Office Action Summary

10/689,465

CLARK ET AL.

DETAILED ACTION.

Ex's
Attachment
8/20/04

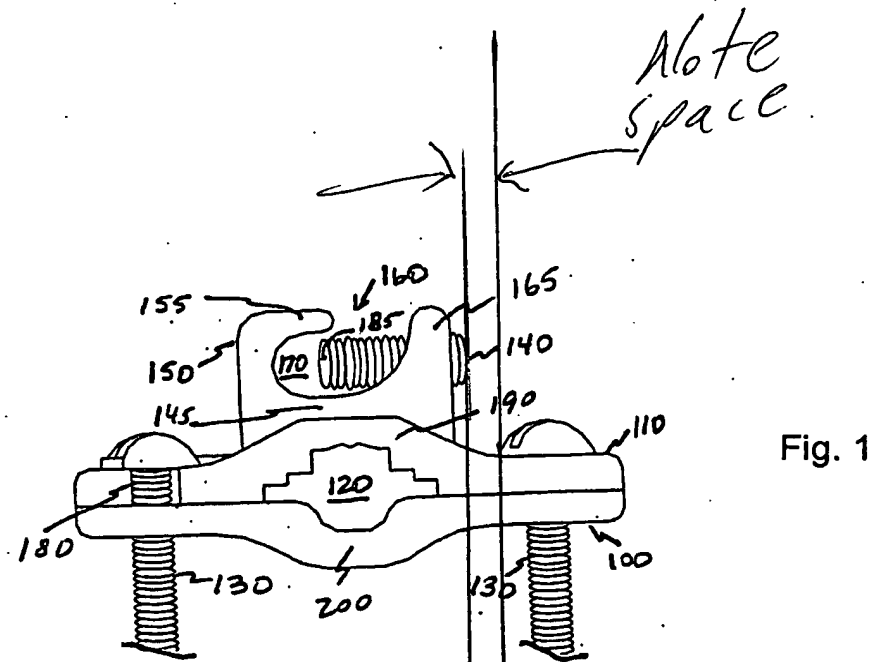
Claims 9 and 11-17 are rejected under 35 U.S.C. 112, first paragraph, as failing to comply with the written description requirement. The claim(s) contains subject matter which was not described in the specification in such a way as to reasonably convey to one skilled in the relevant art that the inventor(s), at the time the application was filed, had possession of the claimed invention. Regarding claim 9, the apparatus as claimed including that the set screws extends to prevent the removal of one of the screws was not described in the specification in such a way as to reasonably convey to one skilled in the relevant art that the inventor(s), at the time the application was filed, had possession of the claimed invention. Nothing is mentioned in the specification

regarding this feature. In fact the figures show quite the opposite (see attachment), in particular that the set screw is shown as being spaced from the path of the screw 130. The limitation is given little weight and must be removed.

Applicant is required to cancel the new matter in the reply to this Office Action.
